Design Review Board Case #2019-0001

WMATA Building - Block 15 / 2395 Mill Road

Block 15 – DRB Work Session

Block 15 – Sketch of Ideas

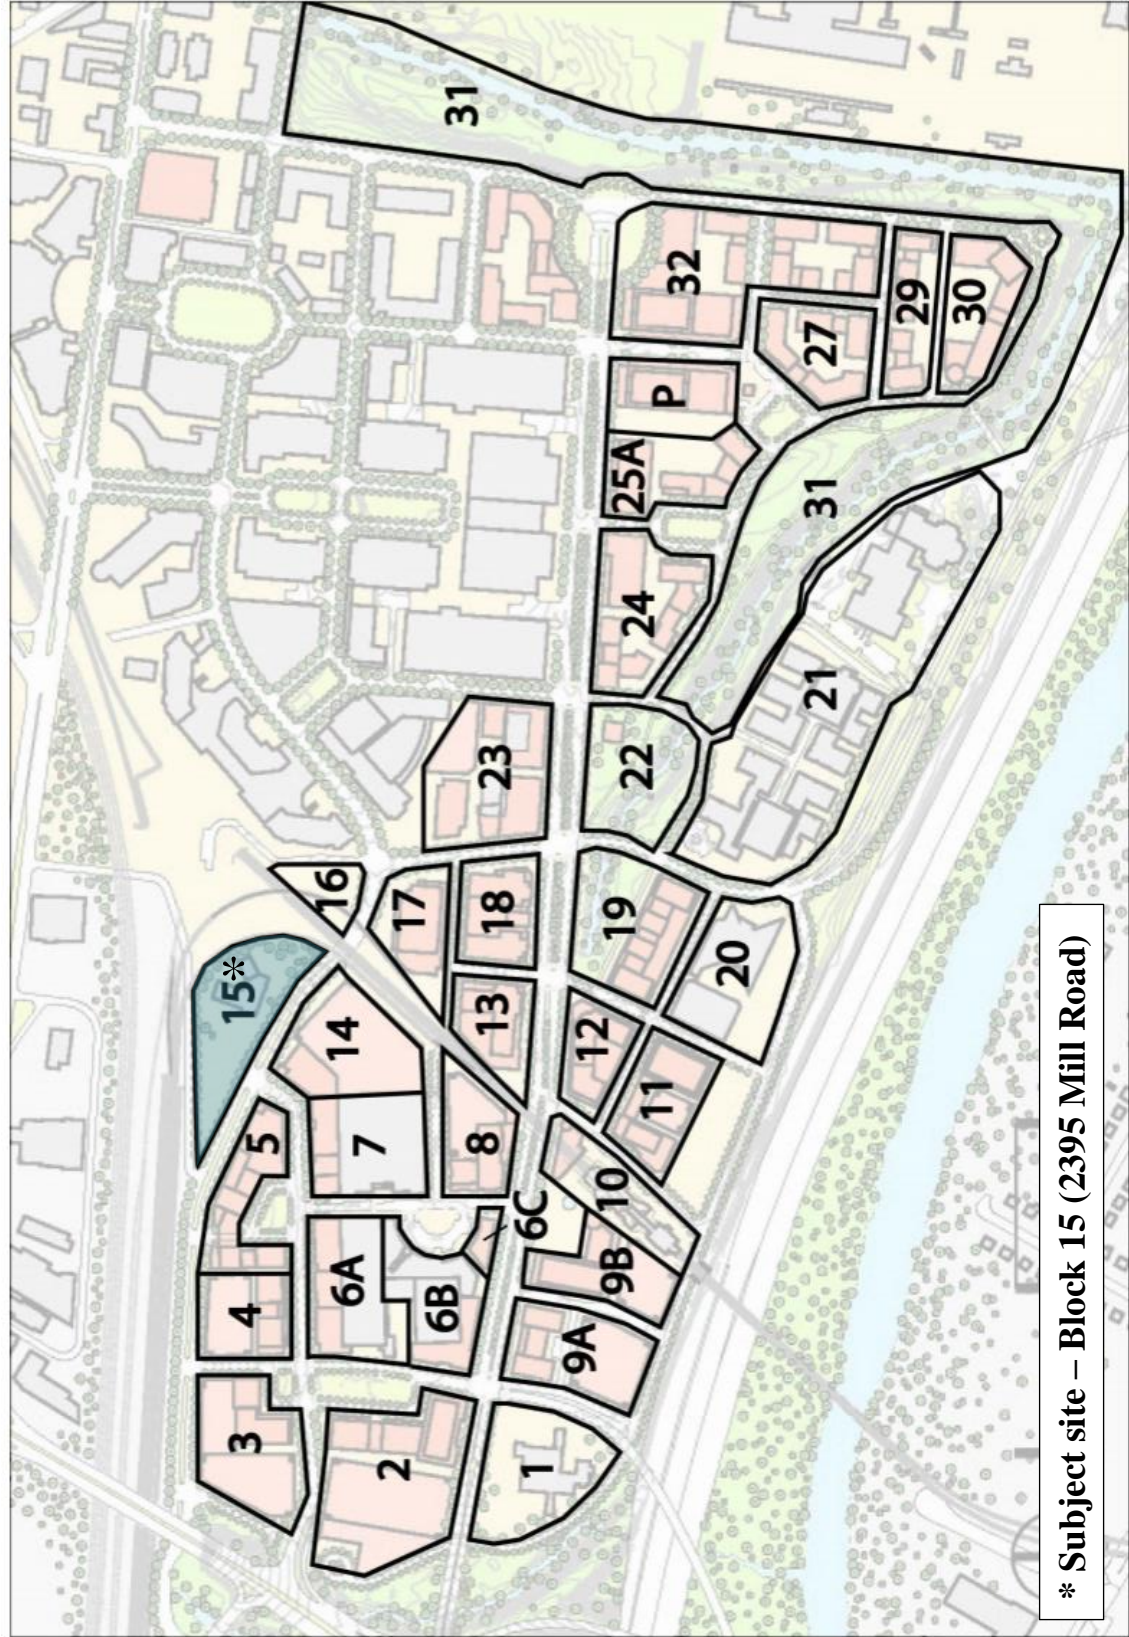
1. Elimination of 3rd (westernmost) curb cut.
2. Reduction in size of visitor lot, along with pavers and considerably increased landscaping.
3. Combination of lobby, visitor and main parking access at end of Mandeville Lane.
4. Suggestion to provide agreement for shared [service] access to future EE 15B site.
